**Falcon Place (SUB 12-01)  
Submission for Completeness**

3J Consulting acts on behalf of OLC 14, LLC. and JT Smith Companies in preparing this letter to address the incompleteness notification released by your office on December 13, 2012 relating to the Falcon Place Subdivision. This letter has been prepared to both address each of the items listed within the City's incompleteness determination and to describe the changes which have occurred to the preliminary plans and submission materials.

**Project Name: Falcon Place (SUB 12-01)**  
**Project No: 12093**  
**RE: Stormwater Management Memorandum**

SHEET NUMBER  
**C2.3**

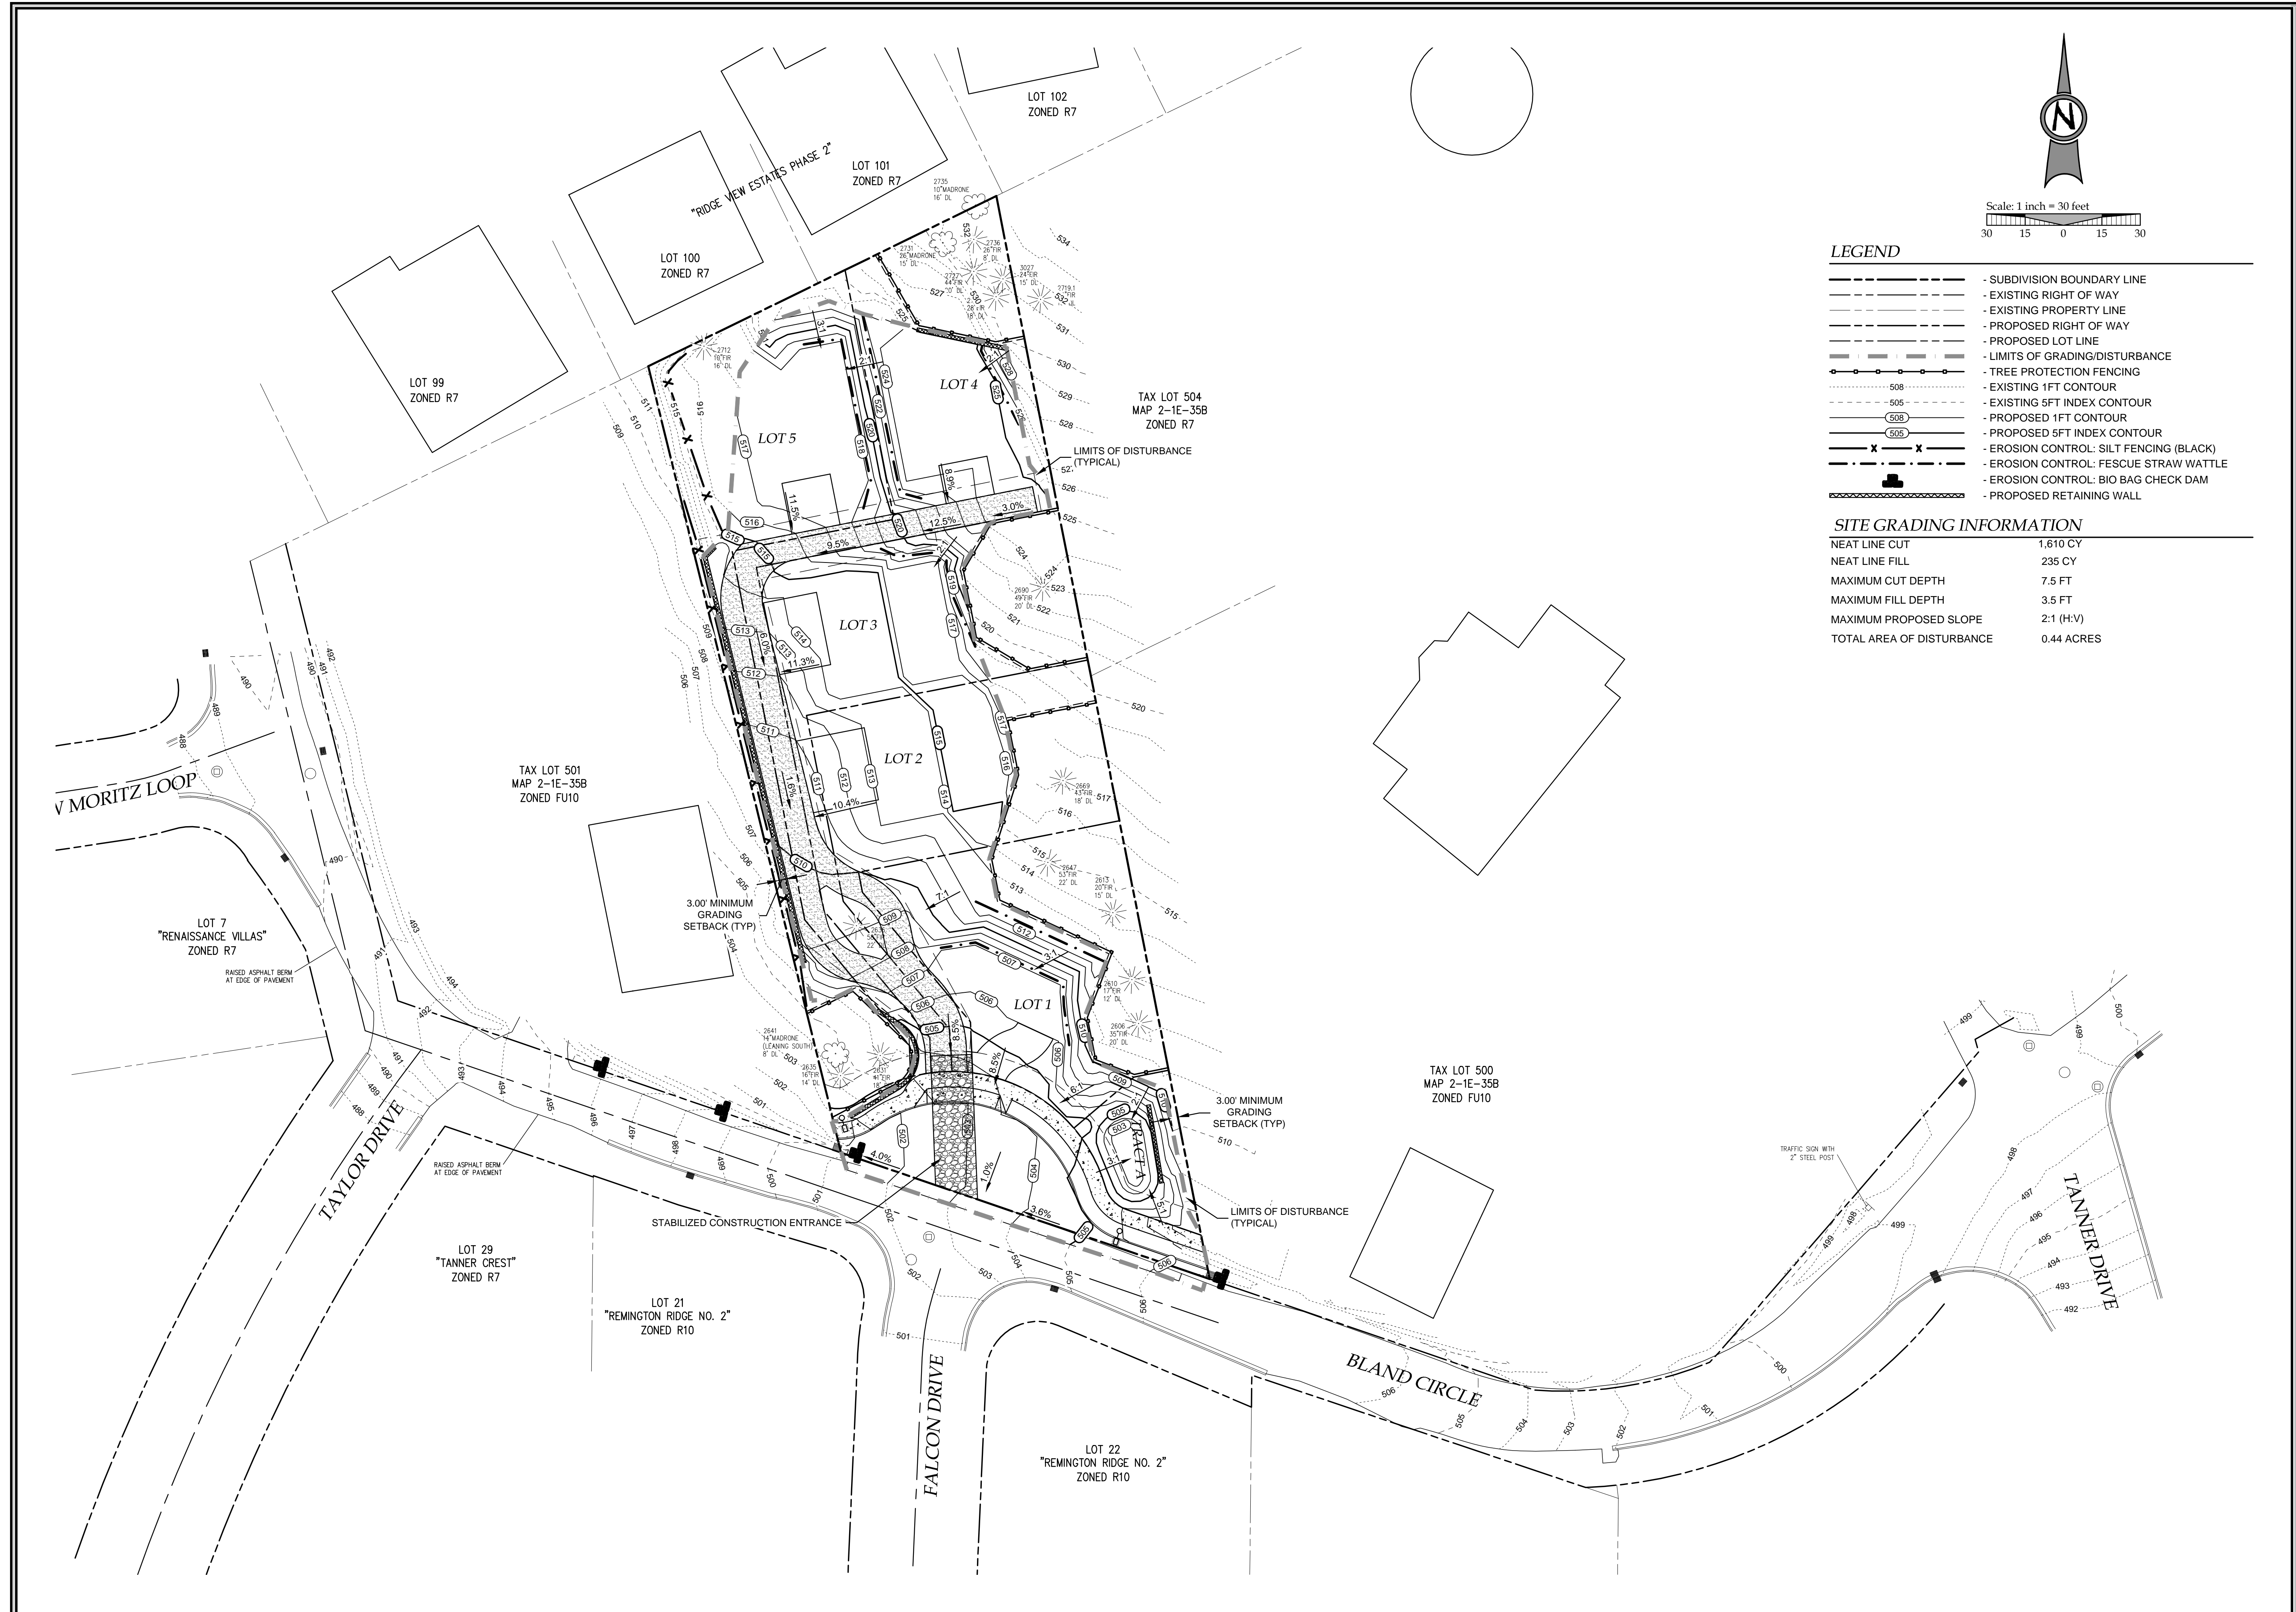
85.160(F)(2)	No erosion control details for construction of driveway where it ties into Bland Circle	The proposed Erosion Control/Grading Plan has been revised to show the proposed construction entrance.

SHEET TITLE  
**COMPOSITE UTILITY**  
SHEET NUMBER  
**C2.4**

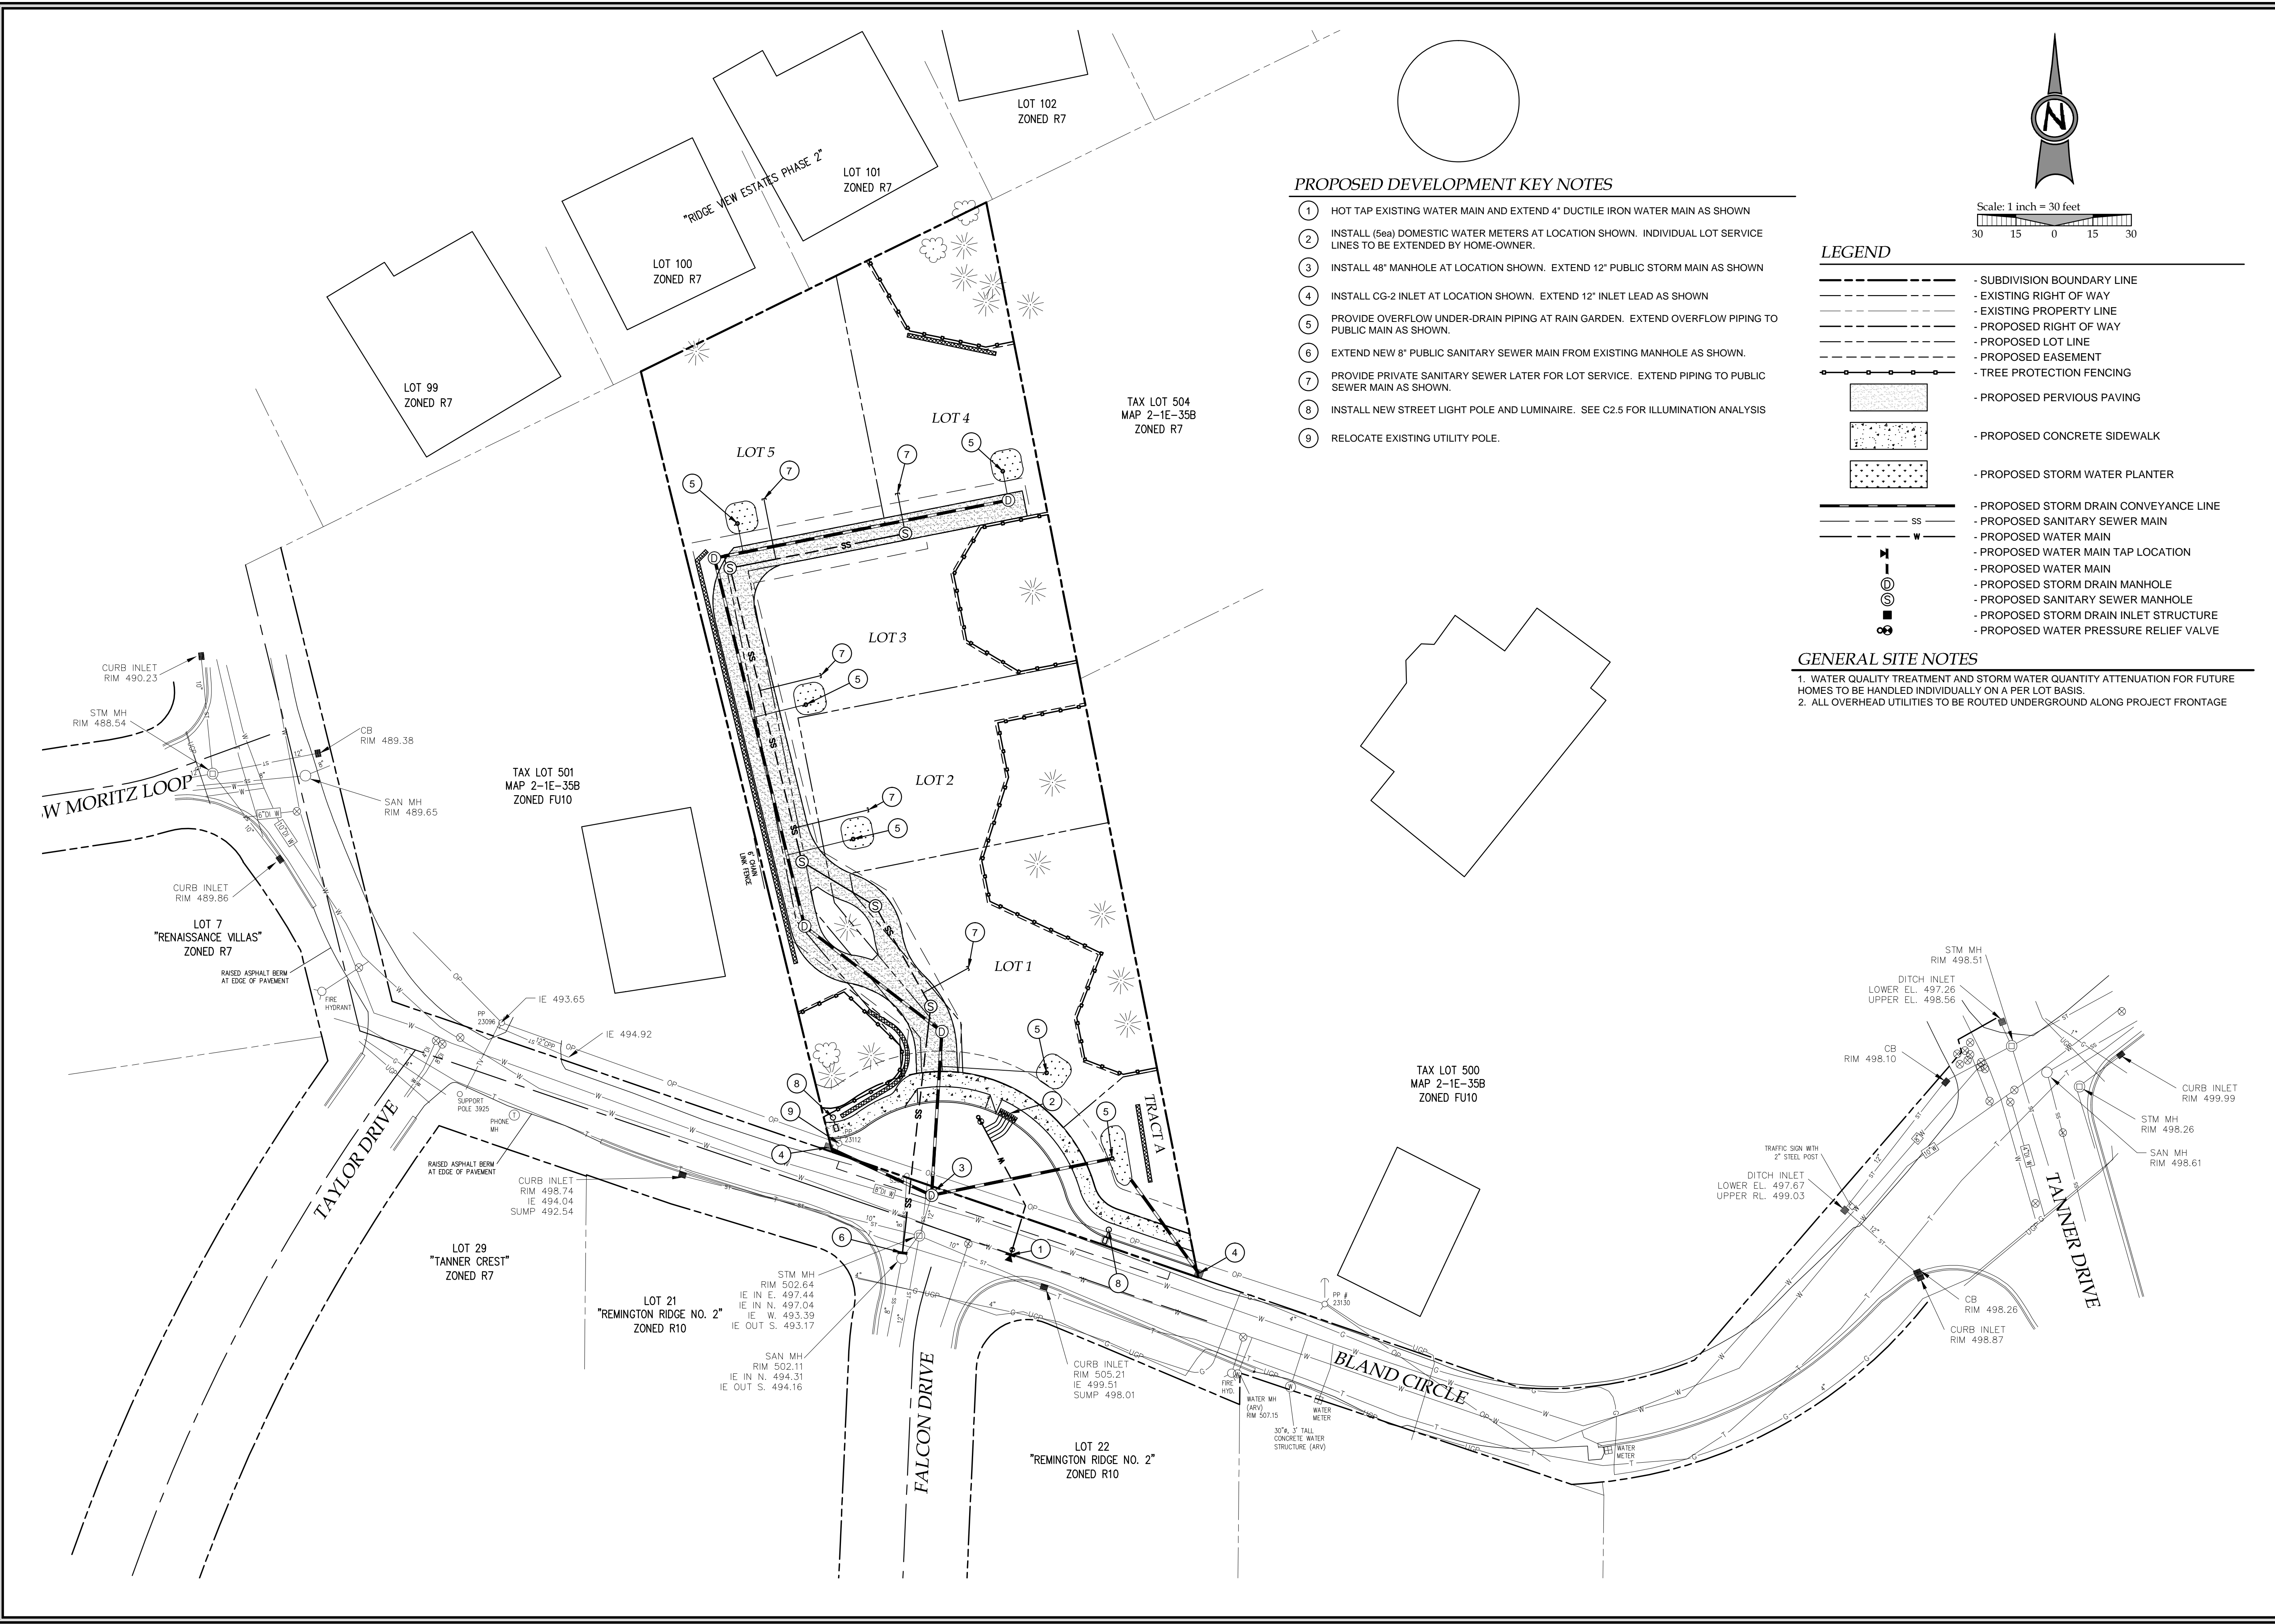
- Show preliminary location of individual storm treatment facility on each lot.
  - Please see Sheet C2.4 for preliminary locations of all individual storm treatment and retention facilities.
